AGENDA
CONCEPTUAL PLAN REVIEW COMMITTEE
Community Room, 3rd Floor
Arlington Heights Village Hall, 33 S. Arlington Heights Rd.
Arlington Heights IL 60005
August 13, 2025
6:30 PM

Item: 1903 E. Euclid Ave. - First United Methodist Church - T1888
Parking Variation, Side Setback Variation

VILLAGE OF ARLINGTON HEIGHTS STAFF DEVELOPMENT COMMITTEE REPORT

Temp File Number: T1888
Project Title: First United Methodist Church
Address: 1903 E Euclid Ave
PINs: 03-28-301-021-0000

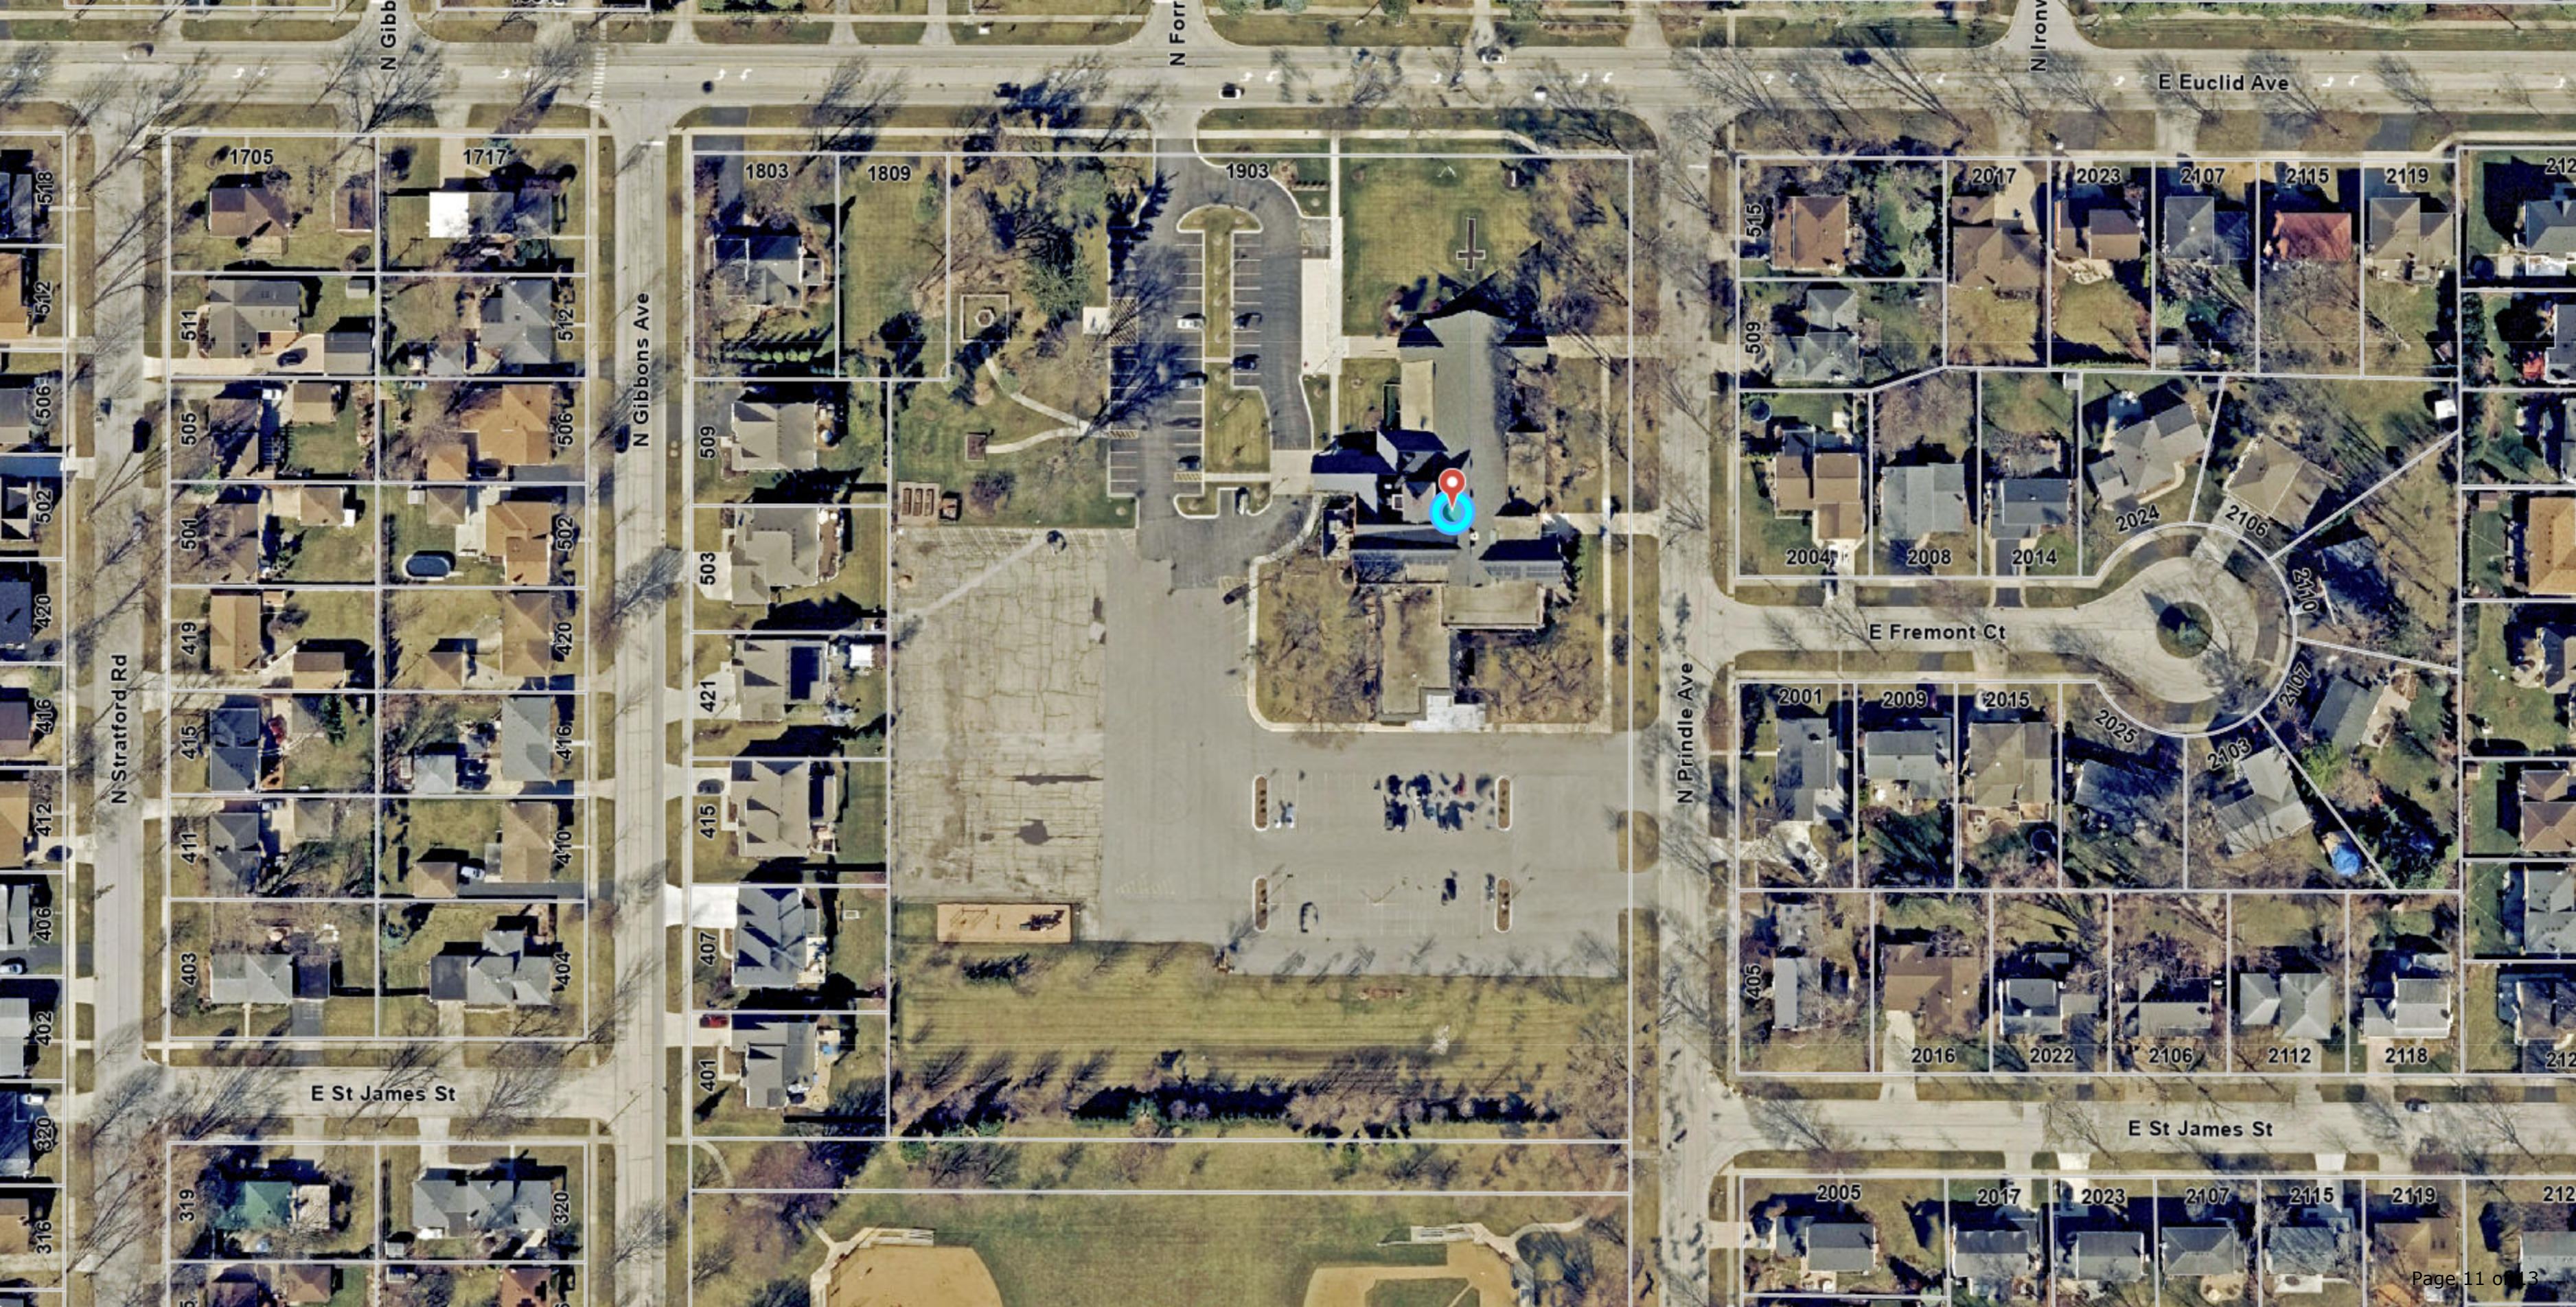
The proposed site modifications will remove a row of parking along the western property line to create a larger landscape buffer and reconfigure parking stalls within the rest of the lot to provide additional spaces. The net increase in parking spaces is 30. The Petitioner shall provide a detailed and scaled site plan that demonstrates compliance with parking stall widths and adjacent drive aisle widths. Parking stalls that are 90-degrees shall be 9-feet wide by 18-feet in length and the adjacent drive aisle shall be at least 24-feet wide. As the site circulation and drive aisle locations are being modified, the SDC will require an Autoturn diagram to confirm fire apparatus access throughout the site.

Landscaping shall be provided adjacent to the parking lot to screen the parking lot from adjacent properties and between the parking lot and adjacent rights-of-way. A six-foot-tall row of landscaping shall be planted adjacent to the parking lot and between residential properties within the new 30-foot buffer area. The Petitioner shall provide a landscape and tree preservation plan with a formal Plan Commission application to identify new species of landscape plantings and removal or replacement of existing trees. It appears that the new 22 land-banked parking spaces at the southern portion of the site

will remove several trees. It is suggested to replant those trees adjacent to the new southern curb line and keep trees, if possible, within the new parking lot landscape island.

The Petitioner shall verify the seats of the assembly area(s), the occupancy of any multi-use area, the number of classrooms and employees, and the total square-footage of office space in the building. Parking lot islands are required at the termination of each row of parking and there may not be more than 20 consecutive parking spaces without an intervening parking lot island. Based on the SDC review, an additional 12 landscape islands are required. The land-banked parking on the southern portion of the site may not encroach into the detention pond area. The SDC has concerns with the amount of space between the current curb line and the expanded parking area encroaching into the detention area considering the steeper slope and landscaping along that drive aisle. If the land-banked parking area is proposed in the formal application, the Petitioner shall ensure that the parking does not encroach into the detention area including the flat landing area on surrounding the detention area. This may require eliminating the overflow parking from the proposal, increasing the potential parking variation.

1. The Petitioner shall provide a detailed and scaled site plan that demonstrates compliance with parking stall, drive aisle, and parking lot island dimensions.

2. The Petitioner shall provide a landscape and tree preservation plan that shows new landscape material to comply with Chapter 28, Section 6.15-1.2.
3. Parking lot islands shall be provided at the termination of every row of parking and there may not be more than 20 consecutive parking spaces without an intervening parking lot island.

7. The land banked parking area on the southern edge of the site cannot encroach onto any portion of the detention area (including the flat landing at the top of the detention facility). Any encroachment may require eliminating the overflow parking from the proposal, increasing the potential parking variation.
